Document Title	Evolution Fuel Vent Replacement
Document Number	SB06-0008A
Date	January 30, 2013

Subject: Lancair Evolution Fuel Vent Installation

Affected Aircraft: Lancair Evolution Aircraft serial numbers: EVO 001- EVO-XXX

Status: Mandatory Service Bulletin

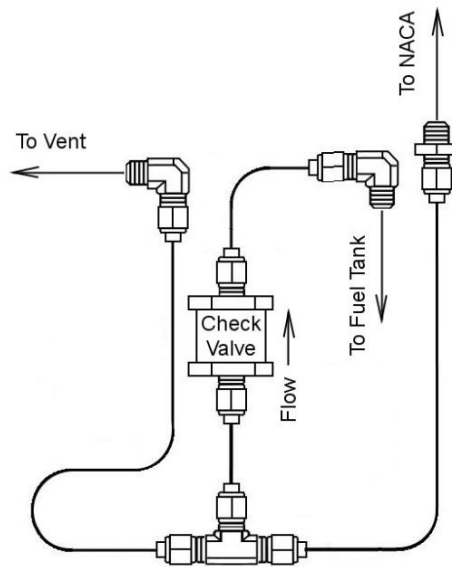
Action: A fuel vent arrangement, as shown in the illustration below should be installed in all Lancair Evolution aircraft.

Lancair strongly recommends using hard aluminum lines for all fuel tank ventilation plumbing. Rubber tubing, as has been seen in some installations may become kinked, which will result in very serious issues including fuel starvation or tank over pressurization. Any rubber tubing should be replaced with hard aluminum lines. Braided hose can also become kinked, although it is less likely. It is the responsibility of the builder to ensure that the fuel vent arrangement meets the requirements of this Service Bulletin.

NACA Vent Configuration

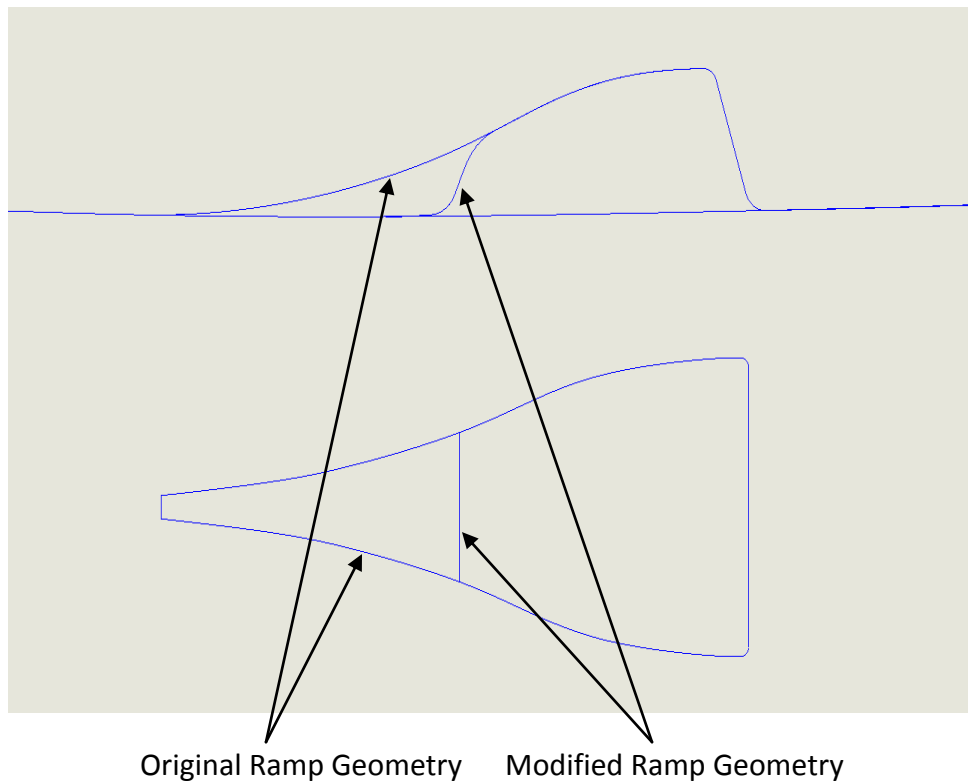
Action: The NACA vent geometry must conform to the configuration shown in Figure 2 below.

This can be accomplished by filling the forward ramp of the duct with a mixture of epoxy resin/micro/flox and shaping until the illustrated geometry is obtained.
